Model	Applicable To	File Under	Bulletin No.
1996 – 97 CIVIC	ALL	BODY	97-056
			Issue Date NOVEMBER 1997

Sagging Headliner

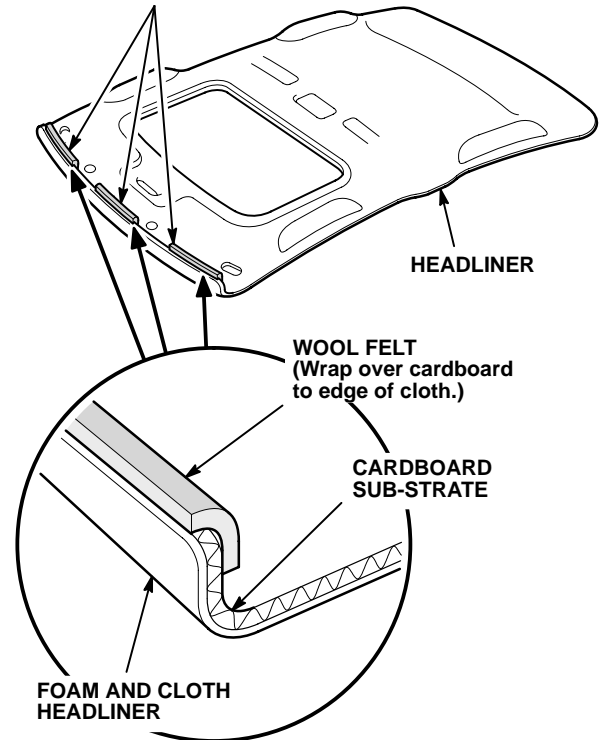
The headliner sags in the front.

The headliner is too long.

4. Apply the strips of wool felt to the front of the headliner as shown.

WOOL FELT, 150 mm x 15 mm
(3 places, position as shown.)
